ADDENDUM NO. 01
BID NUMBER 595
PIERCE TRANSIT MAINTENANCE BASE
BUILDING 4 PARKING AND FUEL & WASH CIVIL

DATE: August 18, 2020

1. Marked-up Drawing CP-111 through CP-113 (For tax application demarcation reference only)
2. Huitt-Zollars Addendum #1 Drawings dated 08/17/2020
3. Huitt-Zollars Addendum #1 Design Revisions Narrative dated 08/14/2020

8 BOLLARD
CP-503 (NTS)

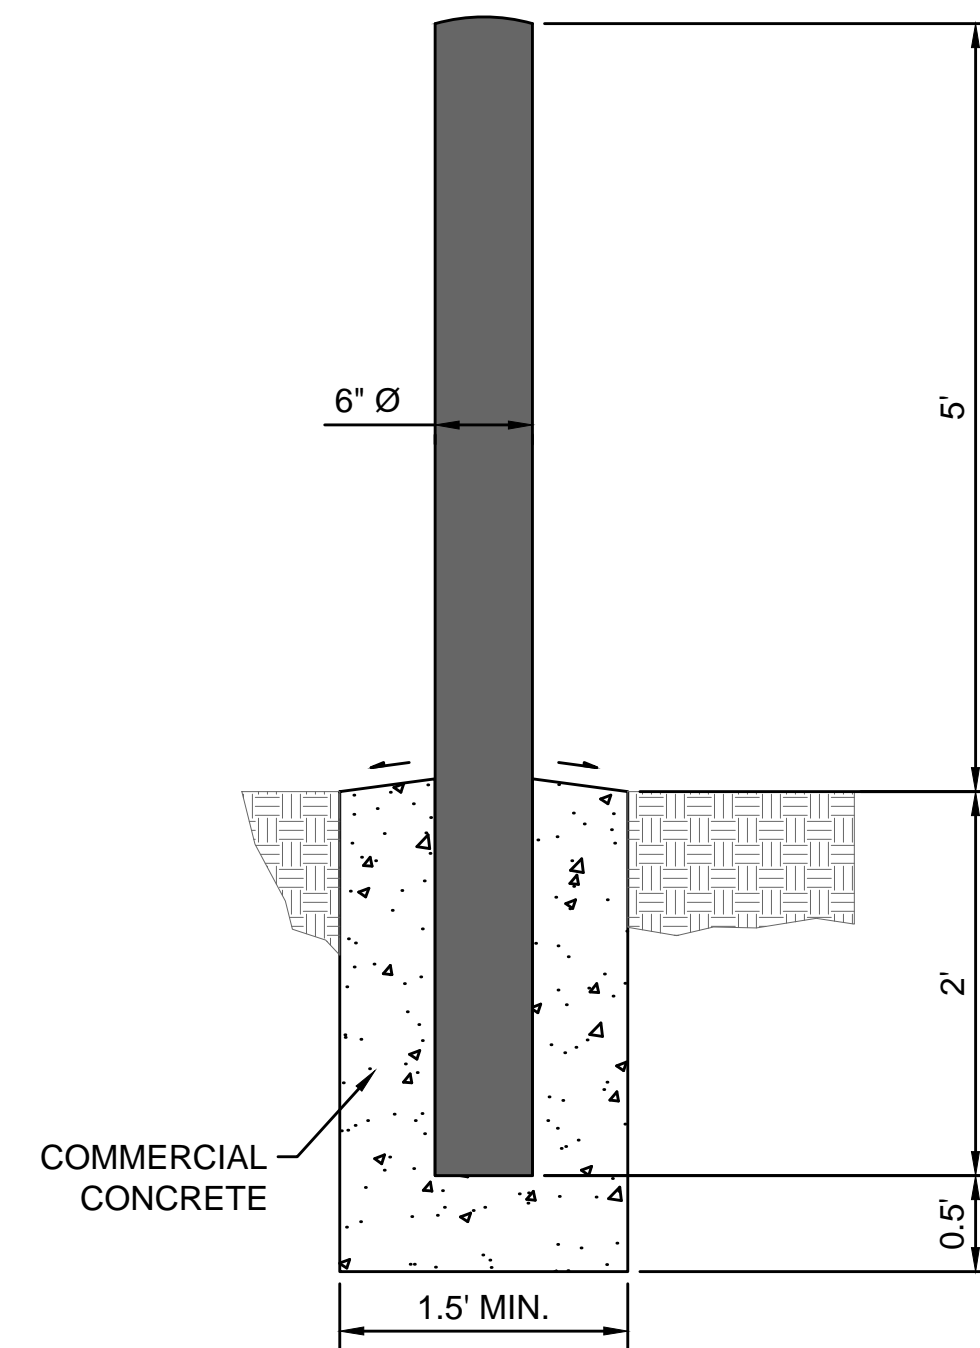
#	DWG/Spec	Description	Comment
5	CP-501	Revise Light Duty Pavement Section B.	
6	CP-501	Add joint sealant details.	
7	CP-503	Add Detail 9 and add surface mount base plate note to Detail PS-05.	
8	CP-503	Revise bollards to be schedule 40 steel.	
9	CP-504	Add "TYPICAL FENCE NOTES".	
10	CP-504	Detail A – CNG TRENCH DETAIL is Not In Contract (NIC)	
11	CP-510	Clarify gate equipment and appurtenances.	
12	CP-700	Revise ramp handrails to be galvanized.	
13	CP-701	Add reinforcement at bottom of stairs.	
14	CP-701	Revise width of wall footing.	
15	CP-703	Revise light pole base details and note number of conduits in pole bases.	
16	CP-705	Revise entire sheet.	Revise concrete paving reinforcement details.
17	CP-706	Revise concrete strength for vertically formed walls.	
Electrical			
1	UE-111 & UE-113	Add note #7, re-number notes #8 and #9.	
2	UE-111	Add callout for Building 4 communications connection point.	
3	UE-111	Add gate reference callout.

9 SQUARE SIGN POST SURFACE MOUNT BASE
CP-503 (NTS)

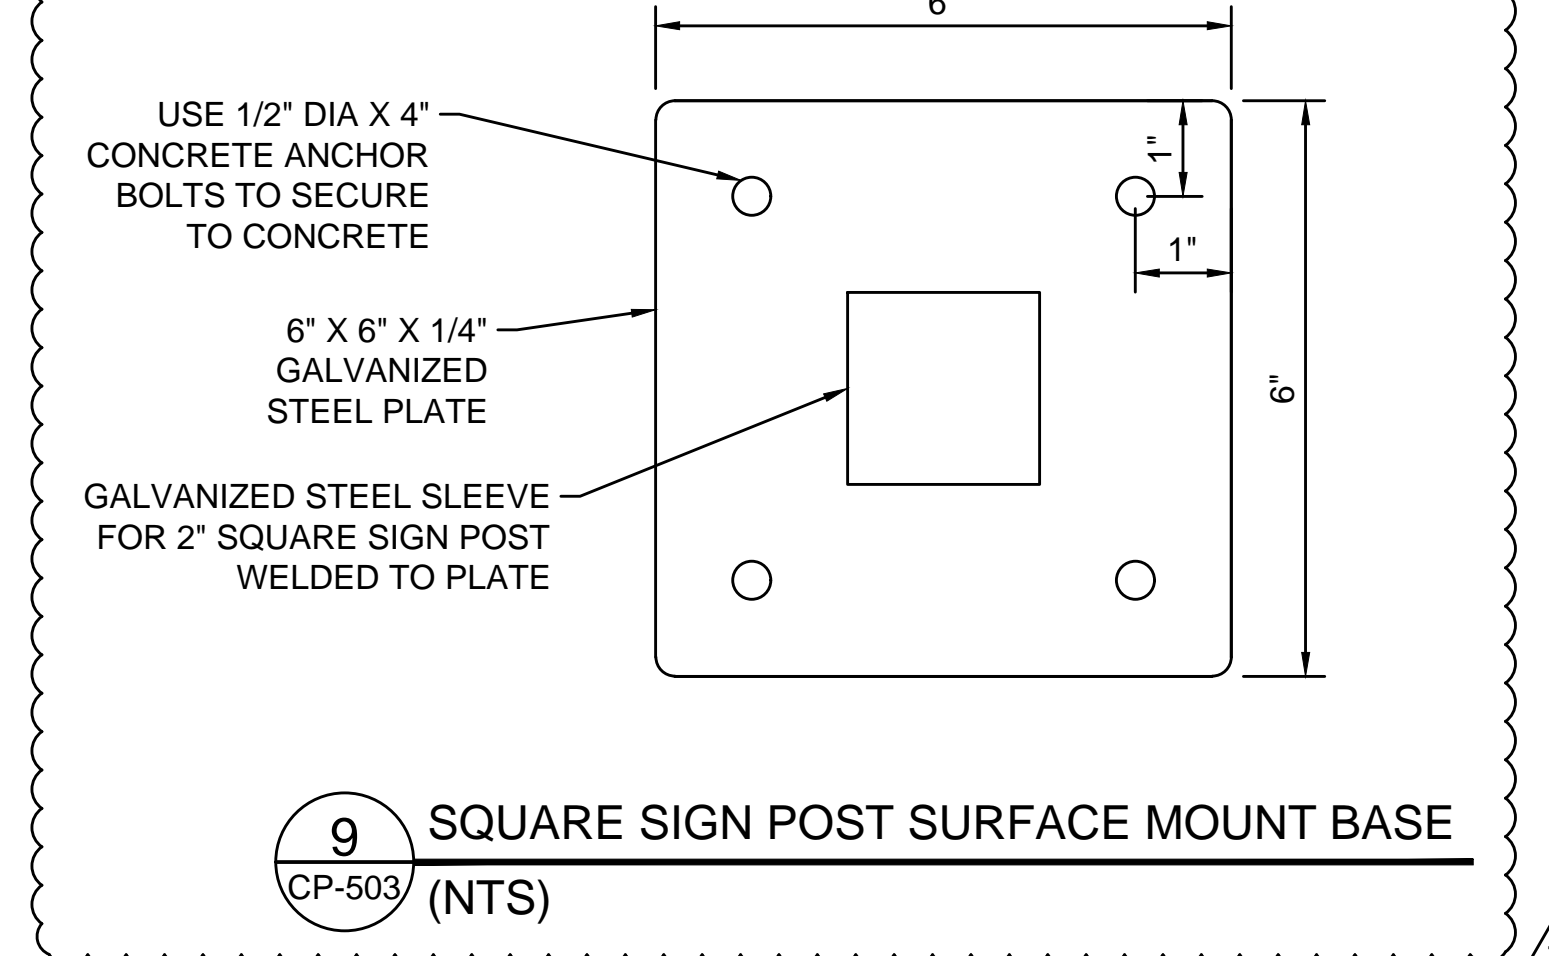
SIGN POSTS IN PAVED AREAS SHALL BE SURFACE MOUNTED. PROVIDE SQUARE POST SURFACE MOUNT BASE PLATE PER DETAIL 9, CP-503, BOLTED TO CONCRETE.
